ADDENDUM #3

Reference: UBATC Vernal Campus Underpass
Uintah Basin ATC – Vernal, Utah
DFCM Project No. 08176250

Subject: **Addendum No. 3**

TRENCH DETAIL

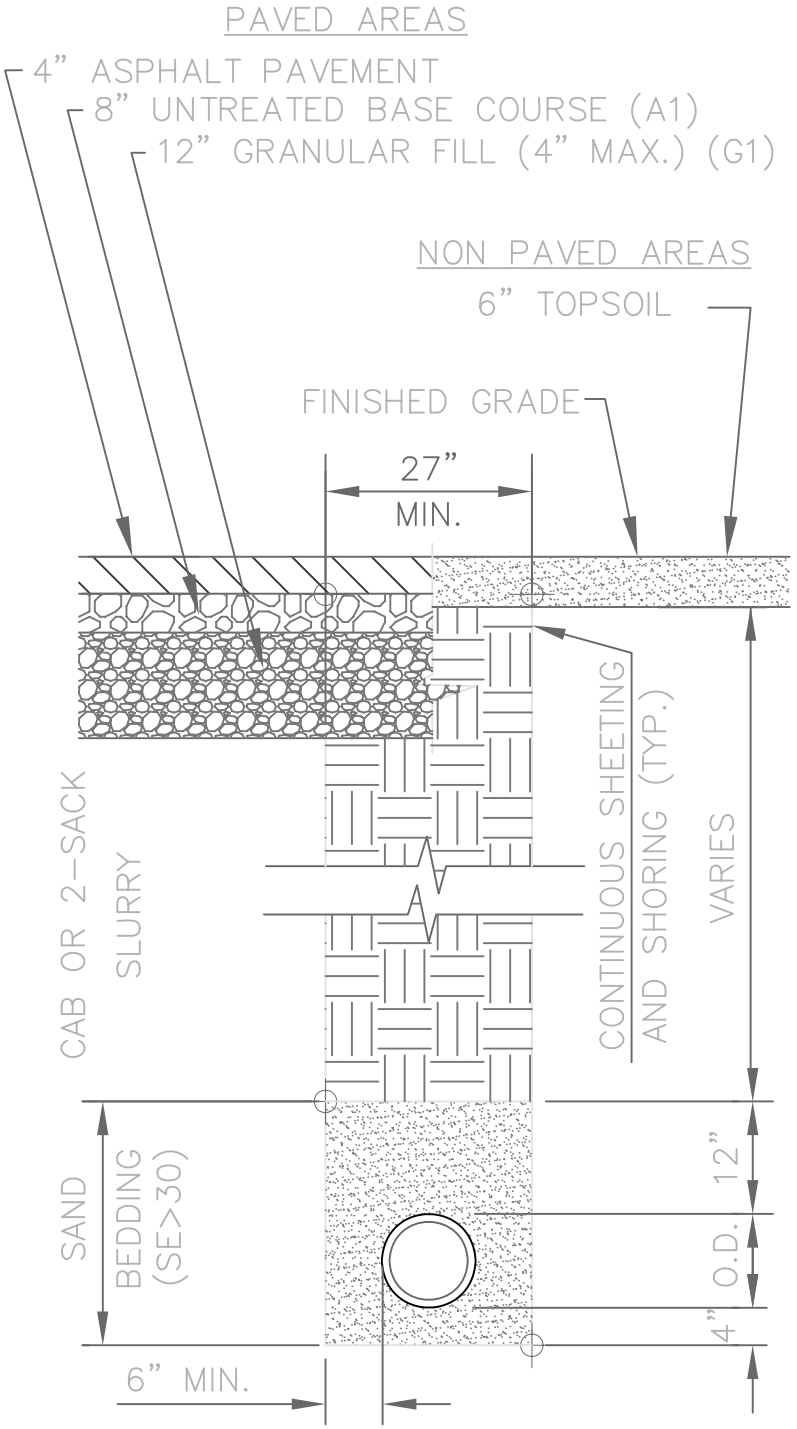
1.2.9 There is no trench detail for the 18” RCP drain line. Please provide detail.
A: See attached detail.

A1 TUNNEL ELECTRICAL SITE PLAN

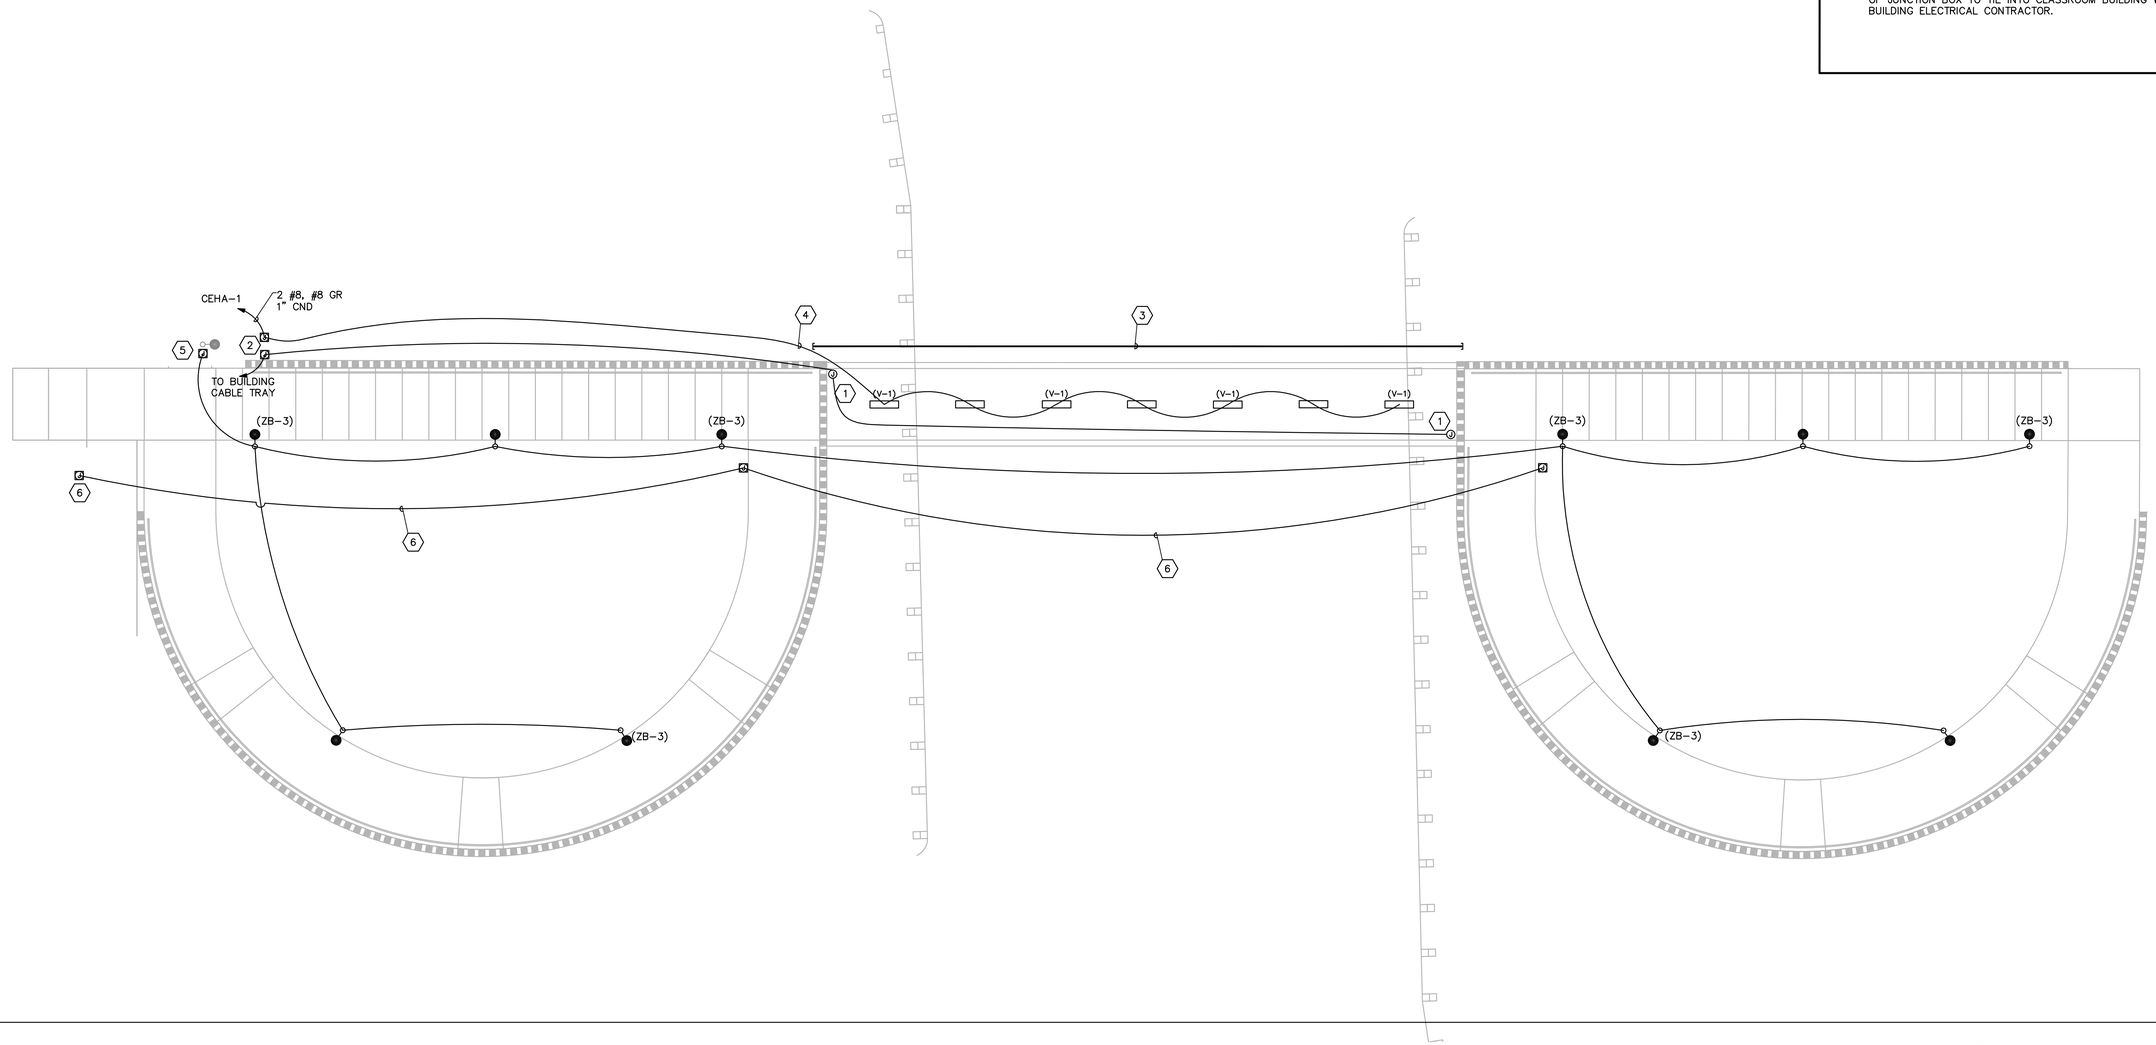
1.2.10 The electrical drawing ES-101 missing. Please provide additional plans, details and specs for a complete electrical design.
A: See attached drawings and specifications.

1. PROVIDE 2 EA. 4" SQUARE JUNCTION BOXES, ONE AT EACH END OF THE TUNNEL, AND 1" CONDUIT TO IN-GROUND JUNCTION BOX FOR SECURITY CAMERAS BY OWNER.
2. 12"X12" IN-GROUND JUNCTION BOX FOR CONDUIT CONNECTION TO UBATC CLASSROOM BUILDING. PROVIDE SEPARATE BOXES FOR LINE AND LOW VOLTAGE CONDUITS. COORDINATE BOX LOCATION WITH CLASSROOM BUILDING ELECTRICAL CONTRACTOR.

3. 4 EA 4" CND, 4 EA 2" CND, AND 4 EA 1" CND DIRECT BURIED BELOW ROAD FOR FUTURE USE. STUB CONDUITS 10' BEYOND UDOT RIGHT OF WAY. CAP AND DIMENSION ON RECORD DRAWINGS.

4. 1" CONDUIT WITH 2 #8 CU, #8 GR.
5. CIRCUIT TUNNEL WALKWAY LIGHTS TO CLASSROOM BUILDING SITE WALKWAY LIGHTS. TUNNEL WALKWAY LIGHTS SHALL BE CONNECTED TO RELAY PANEL RPC1, RELAY #7.

6. PROVIDE 2" CONDUIT AND 12"X12" IN-GROUND JUNCTION BOXES AT DRAINAGE BOXES FOR FUTURE PUMP CONNECTIONS. COORDINATE LOCATION OF JUNCTION BOX TO TIE INTO CLASSROOM BUILDING WITH CLASSROOM BUILDING ELECTRICAL CONTRACTOR.
